Fort Street Public School / Architectural Design Statement
Section 4.55 Modification

Department of Education [SSDA 10340] — REV 04 — 15/04/2021

Upper Fort Street, Observatory Hill, Sydney

/ MET North Stair - Ground Floor

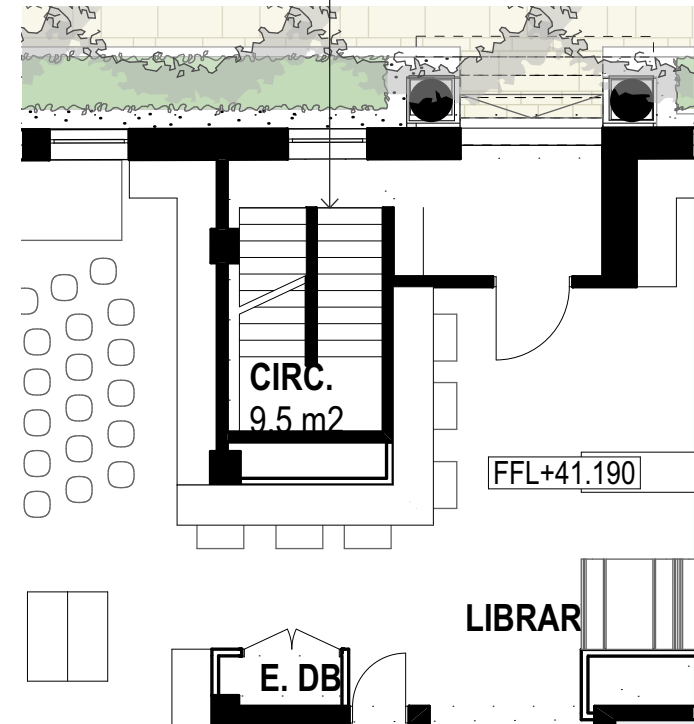
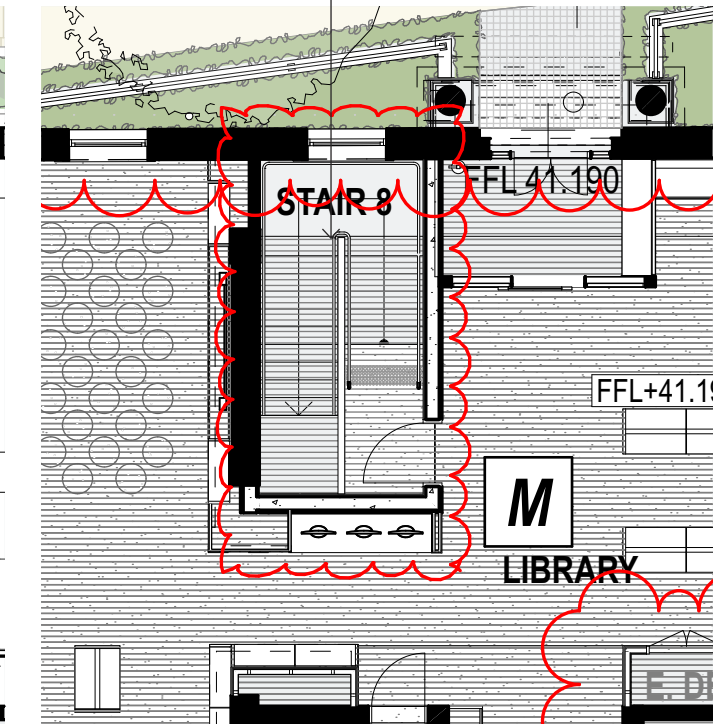
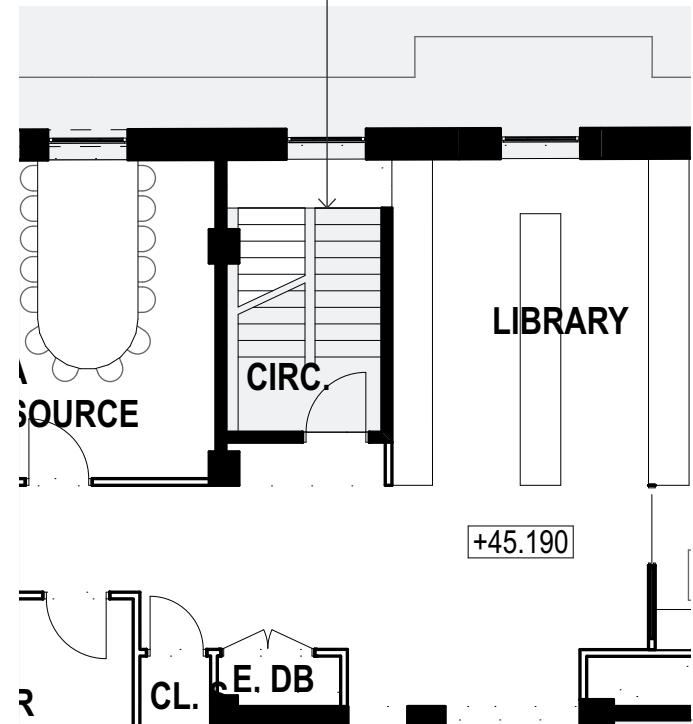
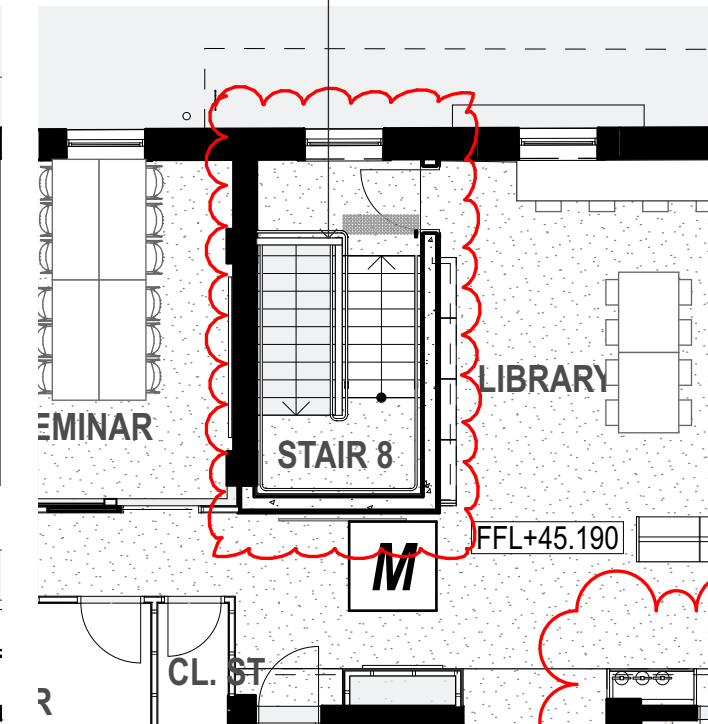
However the existing north stair is a constraint. The stair currently connects Ground Floor to Level 1. Further detailed investigations of the existing structure have revealed that its existing configuration is non-compliant when compared against both the NCC (BCA) and the Department of Education's Education Facilities Standards and Guideline (EFSG) which stipulates DOE specific dimensions of stairs.

Approved SSDA
Existing Stair Retained

S4.55
New Stair

Approved SSDA
Existing Stair Retained

S4.55
New Stair

/ Approved SSDA - Lower Ground Floor Plan

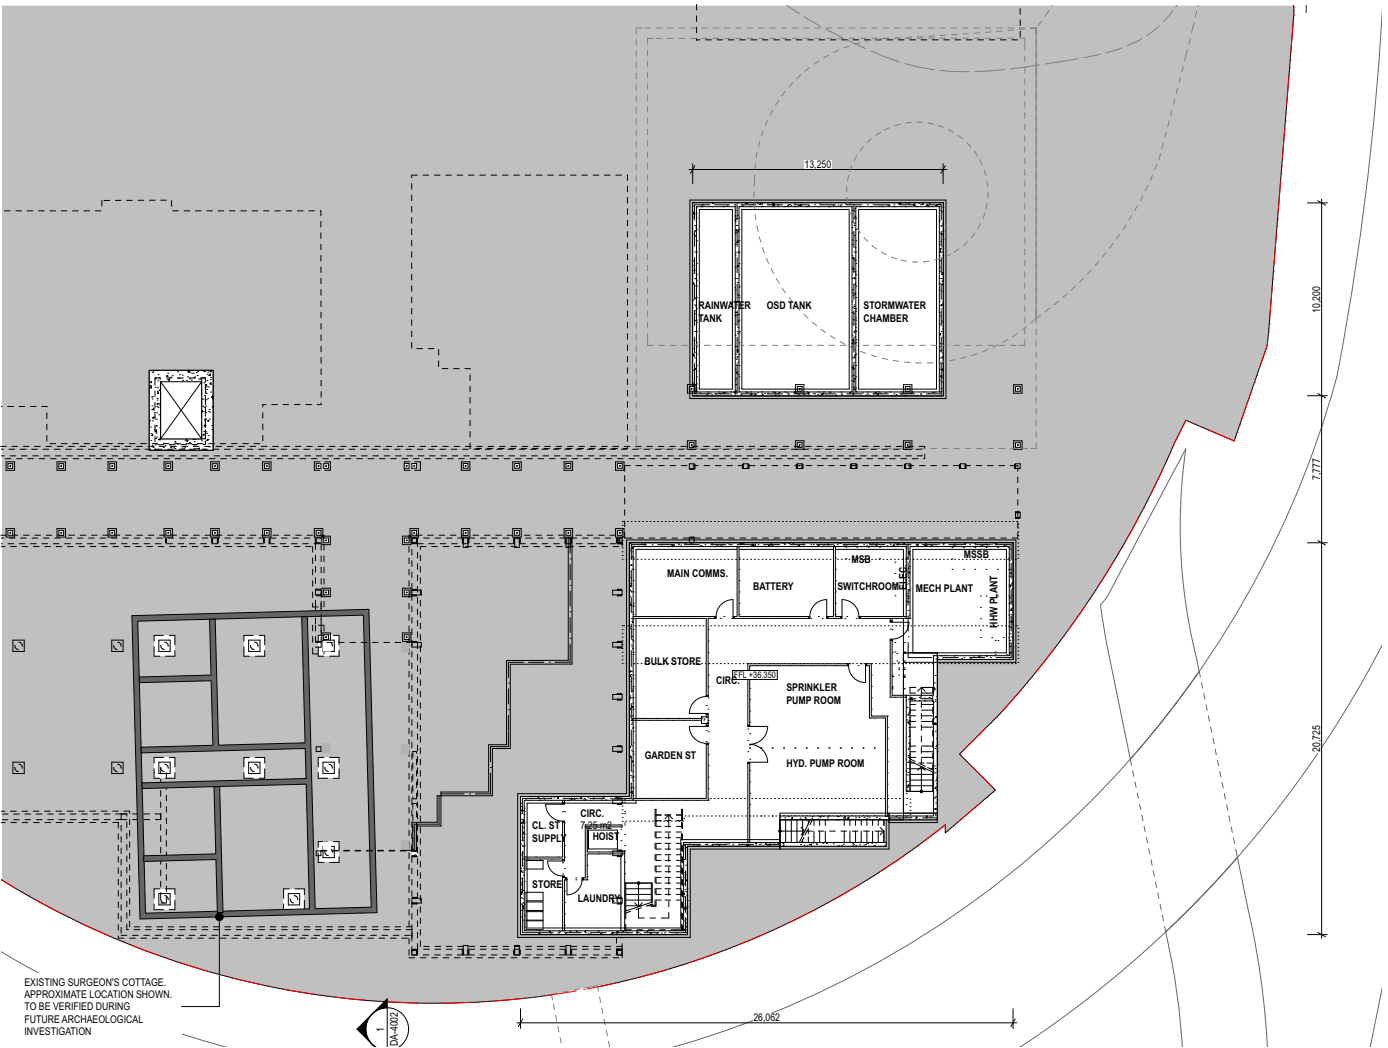
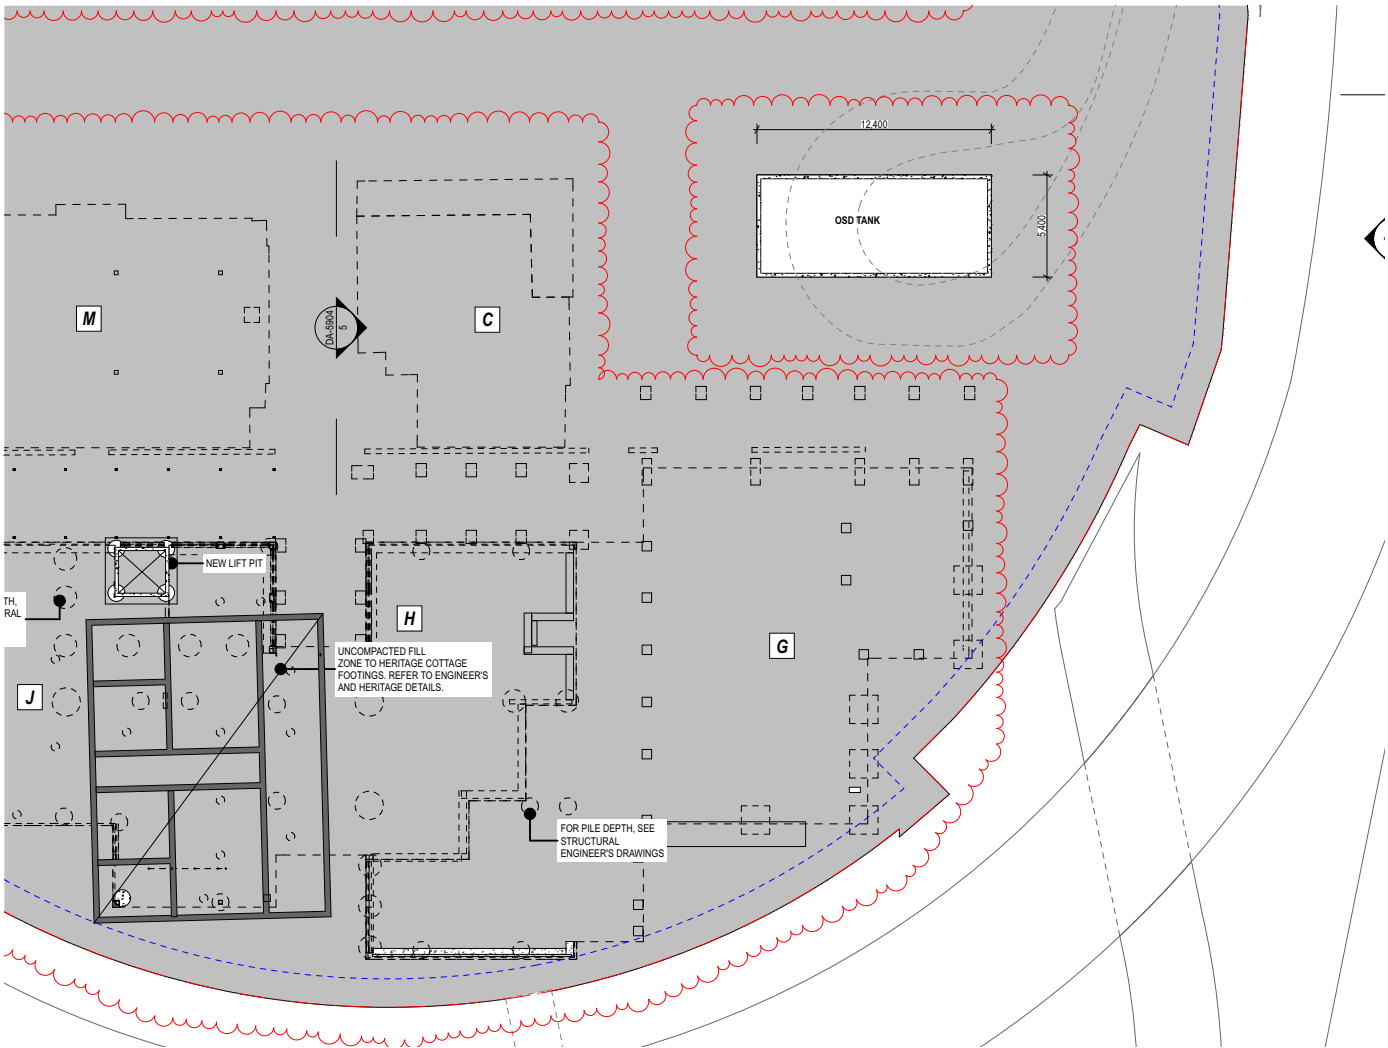
The approved scheme consisted of a lower ground level in Building G (see below) to accommodate stores and various services plant areas. Subsequently further engineering analysis has been conducted in the fire engineering and electrical engineering disciplines to target simplification of the systems proposed.

in the removal of sprinklers from the proposal across all buildings. The measures have in part been driven by a need to ameliorate the impacts upon heritage fabric and fire resisting measures, and also the benefits in deleting the sprinkler system along with its associated infrastructure (storage tanks and pumps at this level, sprinklers and reticulation, etc). Also, the refinement of electrical supply analysis, campus demand, and offset provided by rooftop photovoltaic cells, has identified that the infrastructure previously proposed for the Lower Ground Floor can be partially reduced, and moved to other locations on the campus.

These combined measures have allowed the footprint of these functions at Lower Ground to be removed, hence reducing the volume and extent of the excavations in this area and reducing cost impost.

/ Building A/D Roof PV arrangement

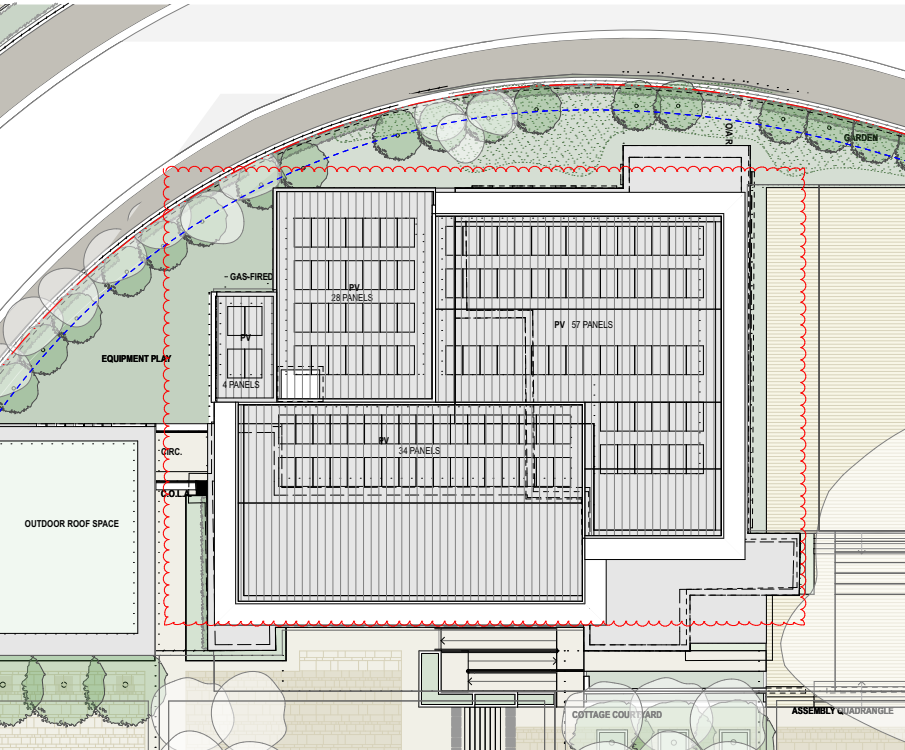
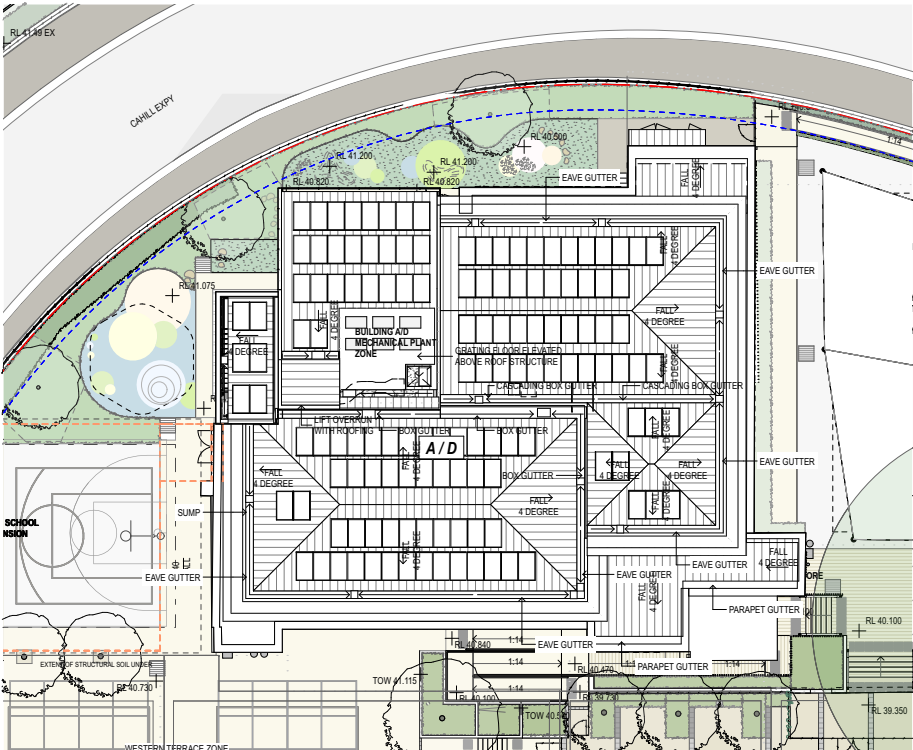
The photovoltaic (PV) cell layout has been revised after detailed services coordination and development. 155 PVs were shown at SSDA. This section 4.55 modification layout proposes 134 PVs which maintains the required 40kW.
